Subject: FRONT SHOCK ABSORBER DUST BOOT CRACK	Bulletin No.: 02-009/17
	Last Issued: 11/10/2017

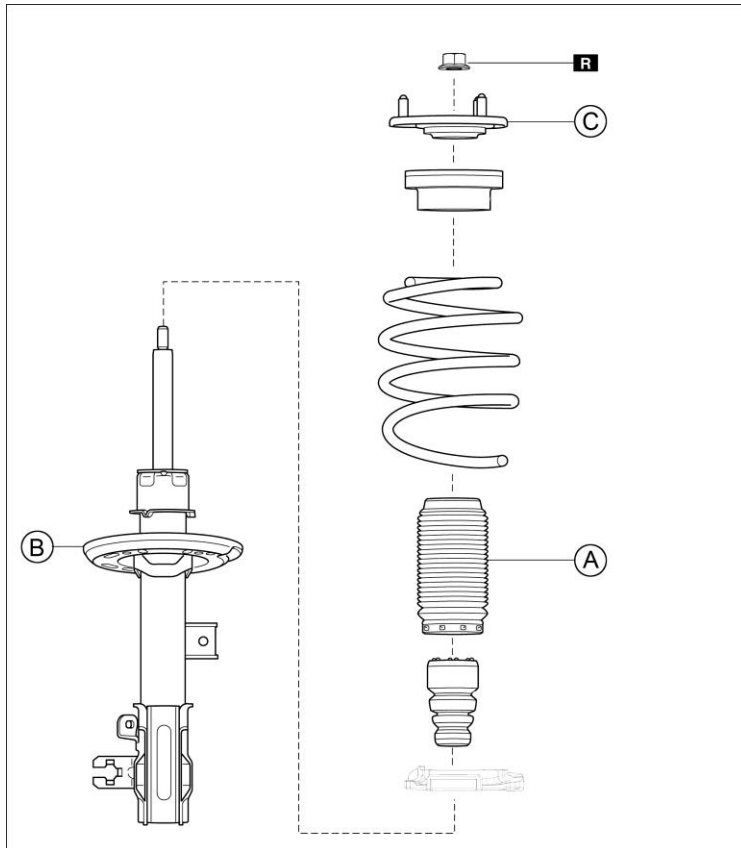
Some vehicles may exhibit a crack on the front shock absorber dust boot (A). This may be caused by dust boot insufficient resistance to cold. The shape and material of the dust boot has been changed to improve the resistance to cold.

1. Verify customer concern.
2. Replace the dust boot (A) according to the instructions on MGSS online:

- Only replace the affected side(s).
- Before removing the mounting rubber (C), put the position mark so the mounting rubber can be installed back in the original position.

CAUTION: It is not necessary to adjust the front wheel alignment because the front shock absorber (B) and the mounting rubber (C) are not replaced. However, make sure to install the mounting rubber to the original position.
